Page 1 of 36 *Resource Name or #: (Assigned by recorder) 100-104 E. Santa Clara St. San Jose

P1. Other Identifier: Hotel Clariana

TCA Architects, provided the proposed architectural plans for the addition to the Hotel Clariana dated October 5, 2018.

Historic Preservation Review
RFI 10/12/2018

Dewing: TCA Architects, A-2-1. July 18,2018 not updated

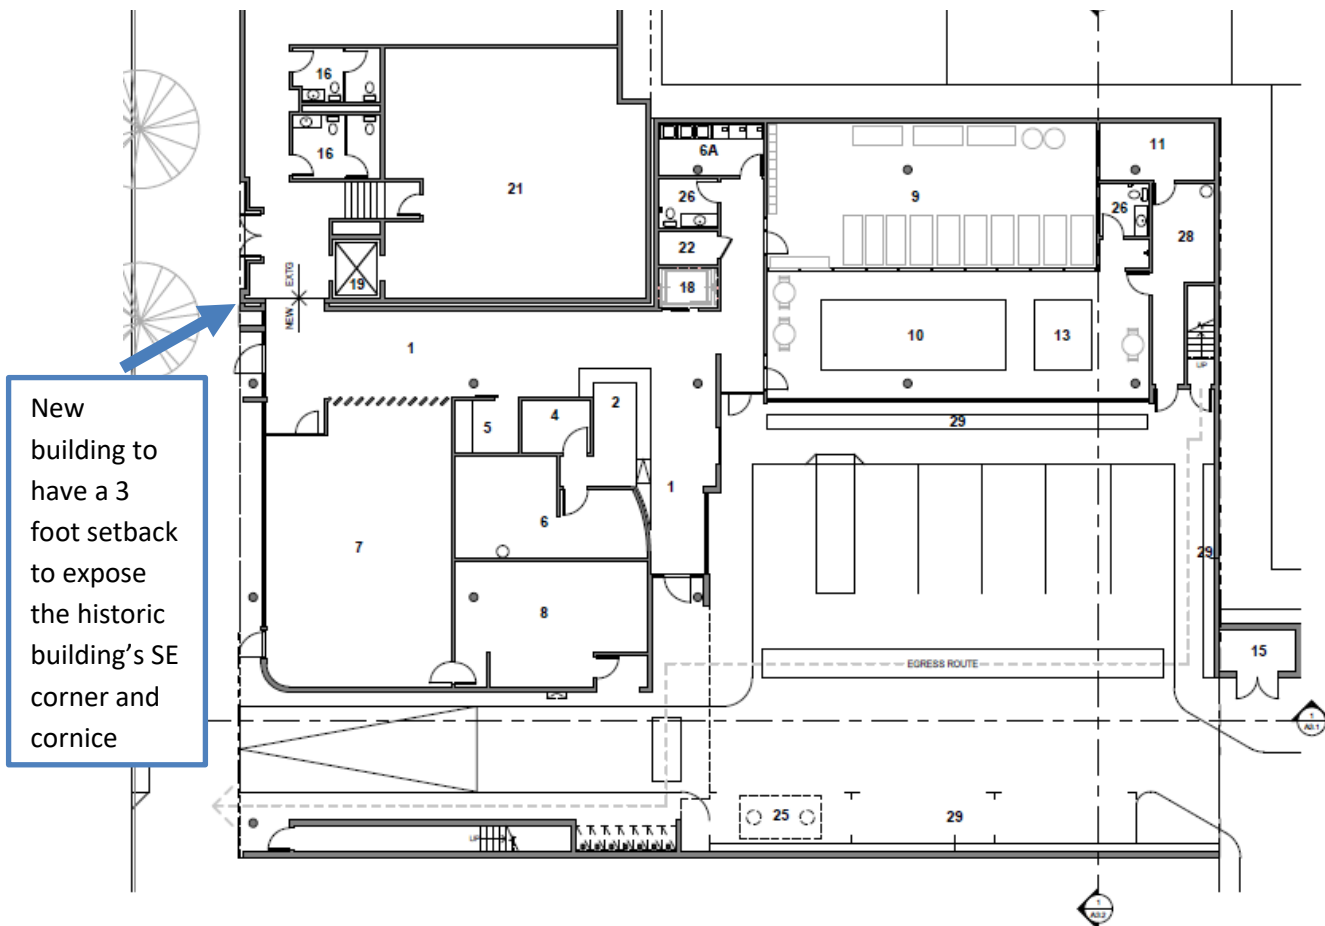
The proposed design on sheets A2.1 (Ground Site Plan) A1.1 (Ground Floor Plan) and A1.2 (Second Floor Plan) show the historic building is isolated from the new addition by a new parallel wall on the north facade of the addition. A modification to the plan now shows the new building set back from the historic building's SE corner. This allows

the corner of the historic building and the cornice return on the fifth-floor to clearly define the size of the historic building.

The set-back from the historic building is approximately 3 feet on the ground level sufficient to provide a distinction between the historic building and the new addition. Beginning on the second floor, the recess between the building was not shown on Sheet A1.3 (floors 3-5) and did not show a the cornice return of the historic building. A revision was made to move the new wall back and retain the cornice return as part of the SE Corner. ³

Architectural Sheet A.1.3 showing the interface between the proposed addition and the historic building on S. Third Street. This perspective shows the setback of the addition that allows the historic building to be seen as a separate building from the street level.

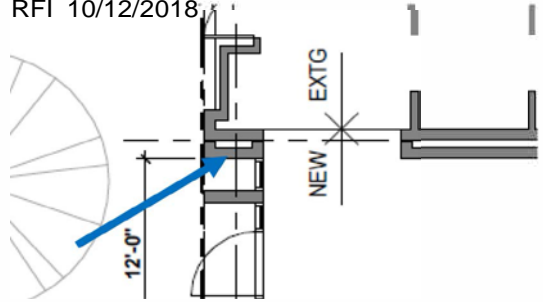
Area of concern: The proposed addition creates an end wall that may obscure the south west corner of the historic building. A recommendation is made to keep the new wall behind the corner of the historic building to allow the historic building to define its corner. The following RFI was submitted by Urban Programmers to TCA Architects. Agreement was reached to allow at least the lower floor to show the historic corner and to maintain a setback at the cornice line and the return at the top of the historic building.

Sheet A.1.2 Second level

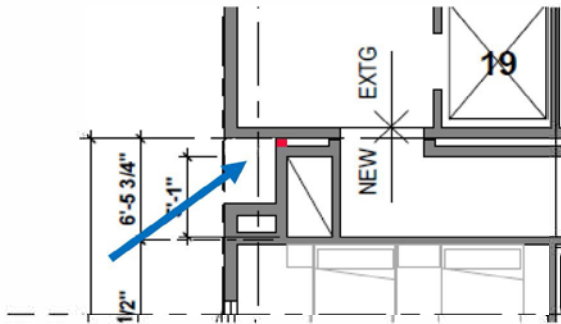
1. Concern: Distinction between the historic building and the new addition on the south facade (S. Third Street). Typically, the City likes to see a setback of 3 ft. behind the face of the historic building.

For this plan, the distinction can be accomplished by removing the small section of wall (ground level to the 5th floor). It appears that this is not a structural wall and would be sufficient to keep the section of the south corner wall and cornice return of the historic building clear of the new addition, and thus clearly show the edges of the historic building and differentiate the two buildings.

Suggestion: Remove the wall at all levels as shown here for the Second Level.

If the cornice return is greater than this space make the chase smaller to show the cornice and wall.
